GTB Document No. CE-5258
Date: 2016-04-05

Extension of Regulation 128 towards Light Sources for Forward Lighting Applications

Example II

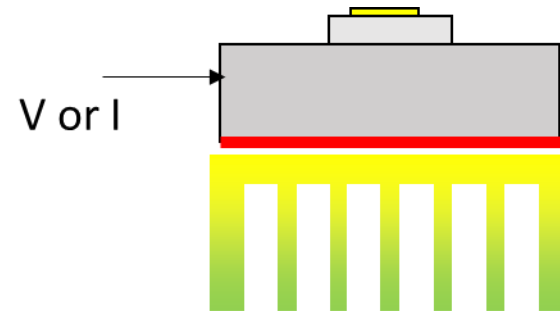
- 1.6. References made in this Regulation to standard (étalon) filament *lamp(s) light source(s)* and to Regulation No. 37 shall refer to Regulation No. 37 and its series of amendments in force at the time of application for type approval.

References made in this Regulation to standard (étalon) LED light source(s) and to Regulation No. 128, including the thermal grade of the LED light source(s), shall refer to Regulation No. 128 and its series of amendments in force at the time of application for type approval.
